PLATTING APPLICATION

PRELIMINARY PLAT: BAKEWELL'S ADDITION GRADING PLAN

To: **Planning Commission**
Through: **Ben Boike, Asst. Comm. Dev. Director/City Planner**
From: **Melissa Sonnek, Comm. Dev. Coordinator**
Date: **July 16, 2019**

Final Plat Application – Bakewell Addition

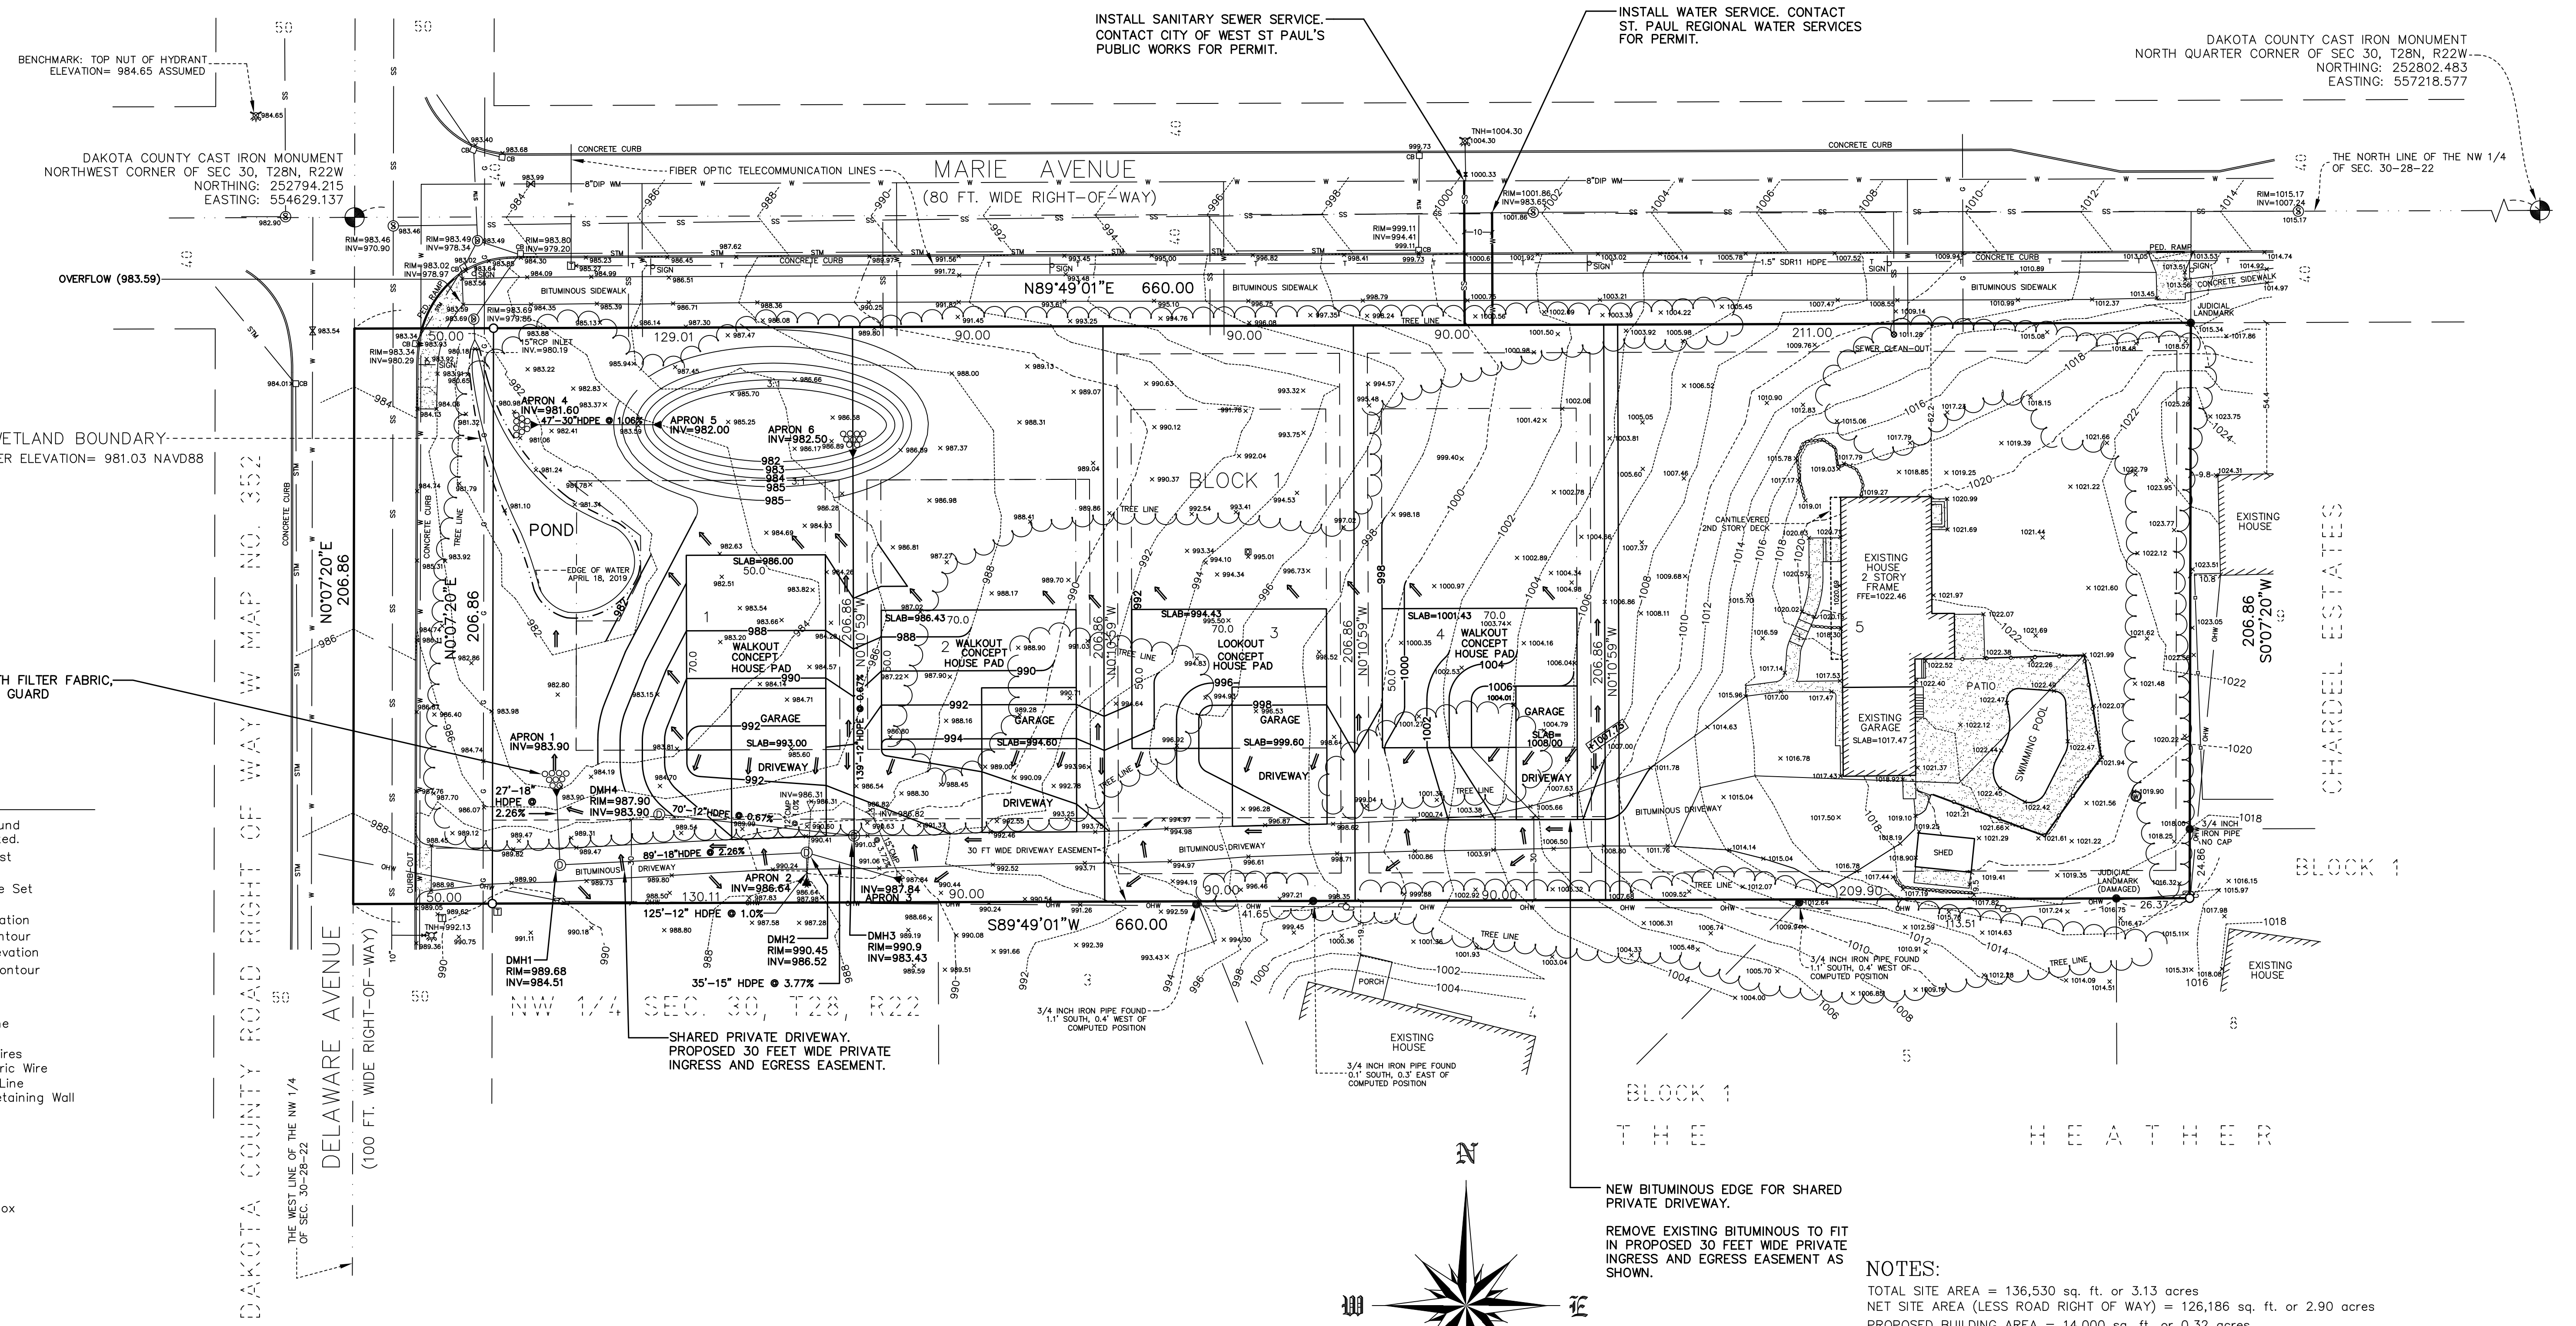
1. A minimum 20-foot wide drainage and utility easement centered over storm sewer within private property is required per the City's Local Surface Water Management Plan. Applicant should update the easement over the 12" HDPE running between lots 1 and 2 to meet this requirement,
2. An emergency overflow (EOF) should be added to the proposed ponding area a minimum of 1.5 feet below the lowest ground elevation of any adjacent structure per the City's Local Surface Water Management Plan. Applicant should confirm rate control requirements are still being met with the addition of the EOF,

3. Structure DMH3 should be moved off the edge of pavement since curb is not being proposed along the private driveway. Applicant should provide the casting information for all proposed storm structures and confirm DMH3 and DMH4 will be open grate manholes, and
4. The proposed storm sewer under the private driveway should be included in the limits of disturbance.
